[Docket No. NHTSA-2010-0162]

Rear Visibility; Federal Motor Vehicle Safety Standard, Rearview Mirrors; Federal Motor Vehicle Safety Standard, Low-Speed Vehicles; Phase-in Reporting Requirements

ACTION: Notice of proposed rulemaking; corrections.

Figure 6. Countermeasure Performance Test Area Illustration and Required Test Object Locations

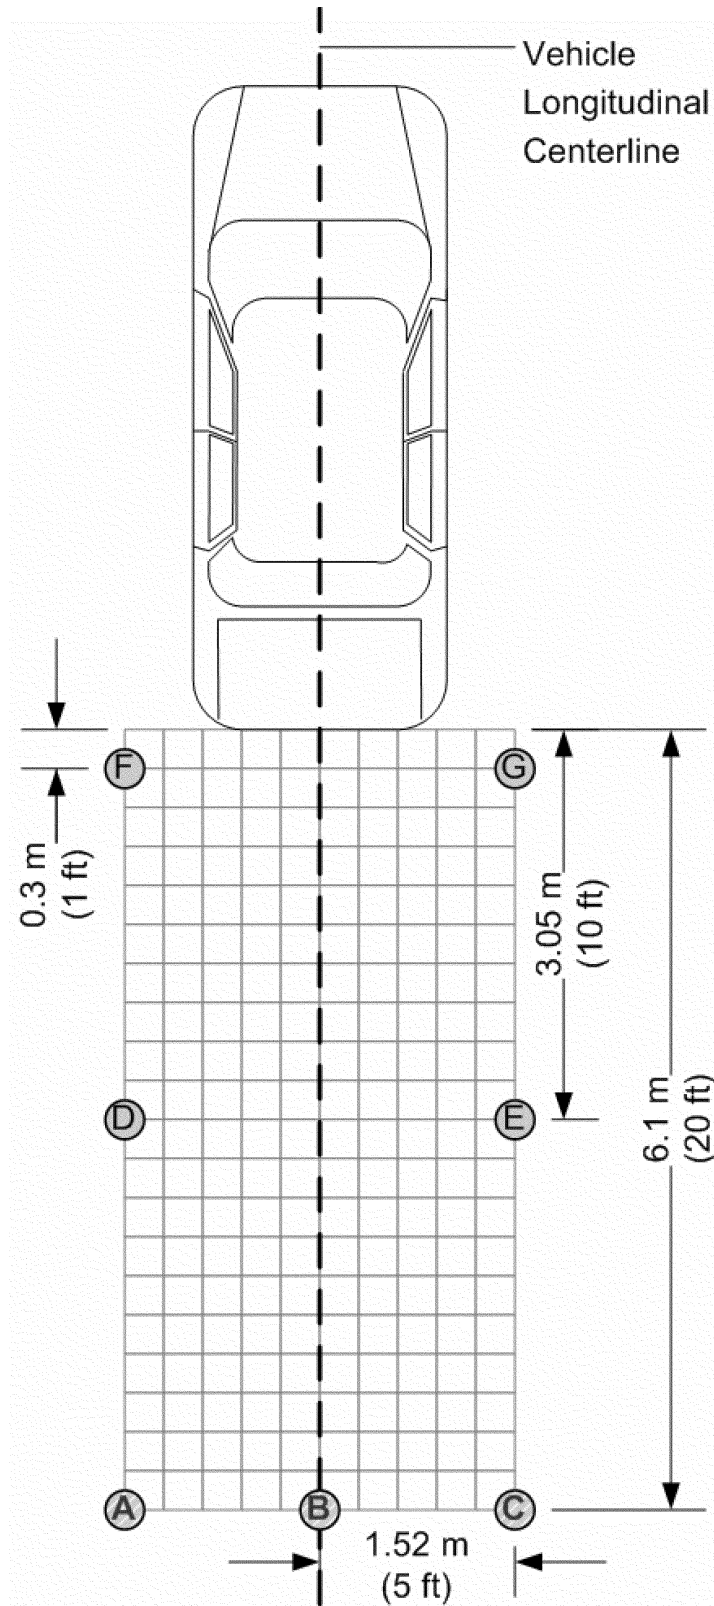
2. On page 76234, figure 6 is corrected to read as follows:

FIGURE 5: TEST CYLINDER LOCATIONS (Units in meters)

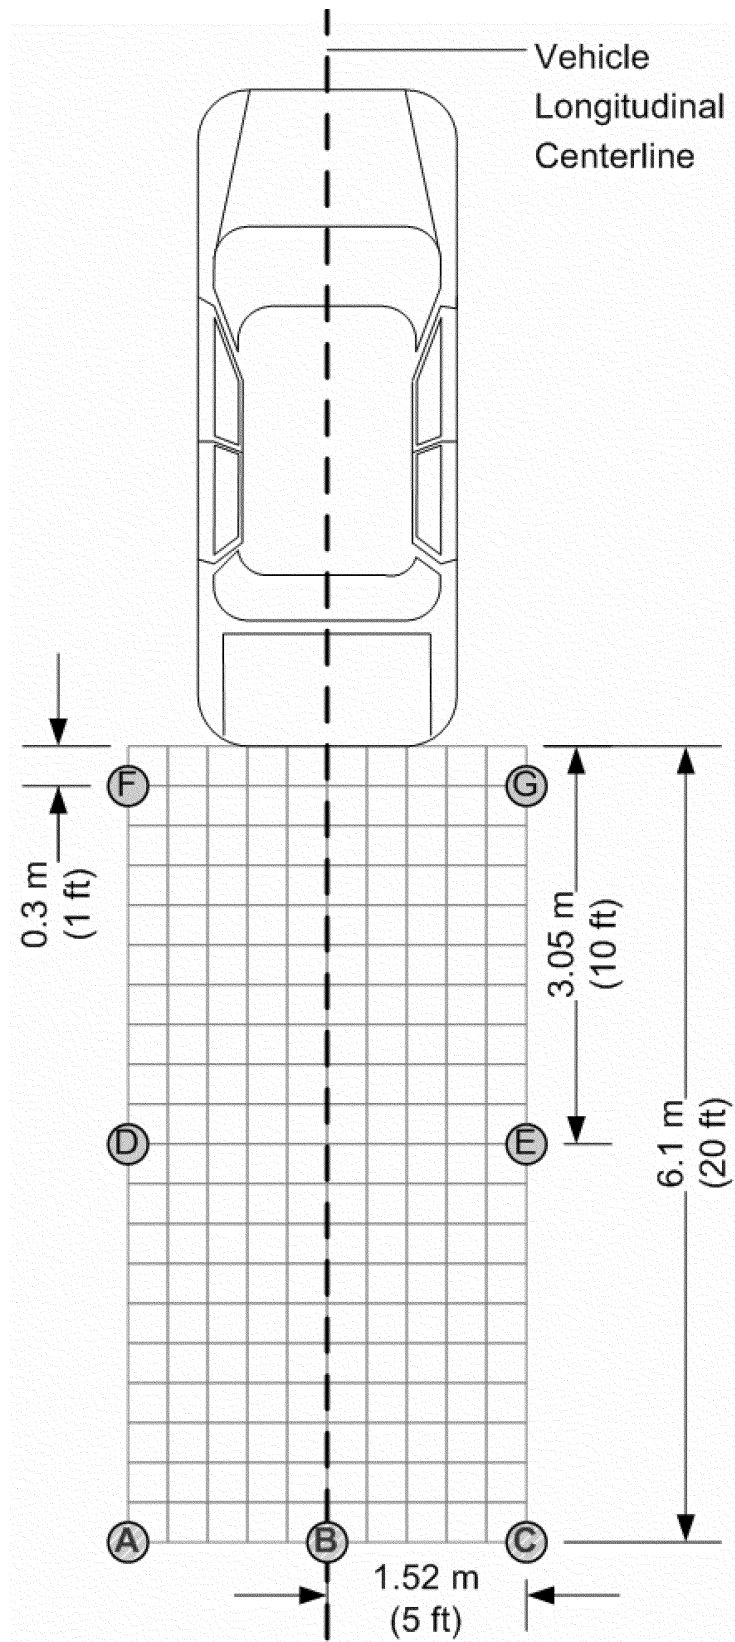
24. On page 76248, Figure 5 is corrected to read as follows:
